**GW - 045**

**Re: Inspection Report, GW-045  
Kutz Gas Plant, Williams Four Corners  
San Juan County, New Mexico**

OCD Inspection: Williams Four Corners, Kutz Gas Plant, GW - 045

Photo 1: Sump contained fluids.

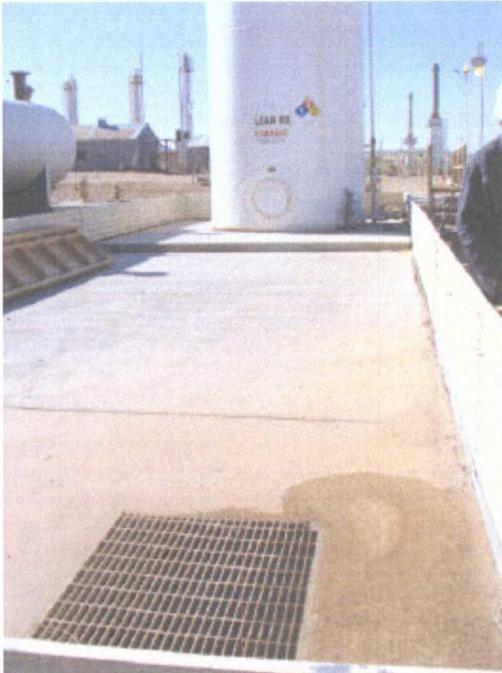
1. **Photos 1 & 14:** Sumps appear to have fluids in them. The permit conditions require that fluids in small sumps be removed within 72 hours. It is not known that these fluids have been present greater than 72 hours; this is just a reminder that fluids shall be removed within the prescribe time referenced in the permit conditions. Williams Four Corners shall inform the Kutz personnel of this condition.

3. **Photos 4 & 5:** Iron sponge is dispersed on the ground. The OCD request; reasons for performing this task; were any ignitability testing completed to the waste sponge; the duration of this practice and any record from the OCD for approval of this activity.

Photo 6: AST with no non permeable barrier.

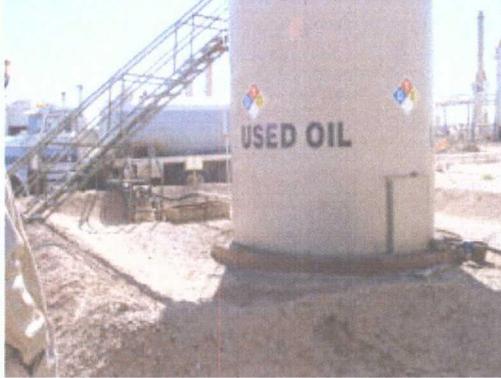
4. **Photo 6:** AST needs to have a liner placed underneath it. Williams Four Corners shall reconfigure AST to conform to the permit requirements before the next permit renewal.

Photo 10: Fluid in pond leak detection system.

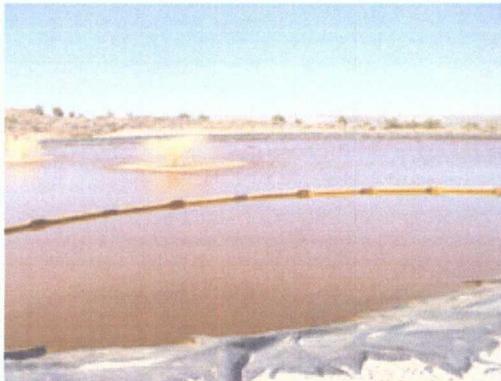
5. **Photo 7-10:** The flare pond located on the southwest site of the facility with leak detection system. Fluids appeared to be in the leak detection system. OCD was informed that the pond previously had a leak in its liner. The OCD is requesting the following: a history of this event and its resolution, including drawings/schematics of pond; the waste acceptance profile sheet for the pond; and the records for monitoring of the leak detection system. Williams Four Corners shall remove the liquids from the leak detection system and monitor fluid levels if present.
